ZONING BOARD OF APPEALS APPLICATION

AREA VARIANCE

NOTICE OF DISAPPROVAL

PLEASE TAKE NOTICE that your application dated October 13, 2020, with a site-plan received on December 7, 2020 to convert a garage into a 2-story, 2-unit dwelling, located at 449 Main Street, in the C-R District, is returned herewith and disapproved on the following grounds:

SITE PLAN

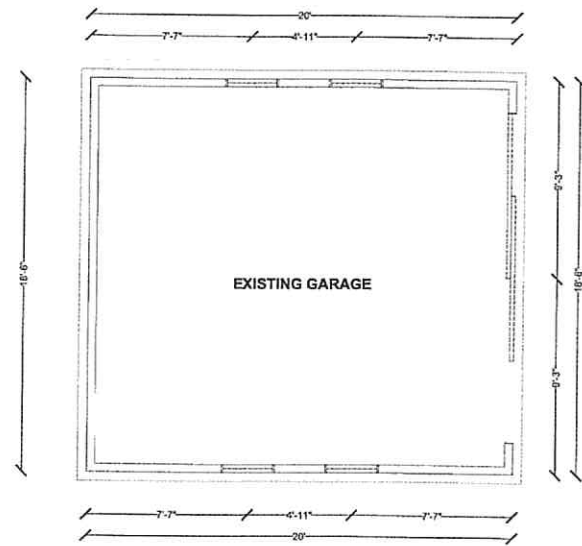
The current building is used as a garage. The applicant is proposing the conversion of the existing garage to a 2-story, 2-unit residential dwelling. An occupancy change is not specified in this article; therefore, area variances must be obtained prior the issuance of a building permit.

The plans show a 1-foot, 2-inch setback off the north side of the existing accessory structure. The minimum setback requirement is 10-feet. This would require a 8-foot, 10-inch area variance.

The plans show a 2-foot, 8-inch setback off the south side of the proposed patio. The minimum setback requirement is 10-feet. This would require a 7-foot, 4-inch area variance.

The plans show a 3-foot, 2-inch setback off the north side of the existing accessory structure. The minimum setback requirement is 10-feet. This would require a 6-foot, 10-inch area variance.
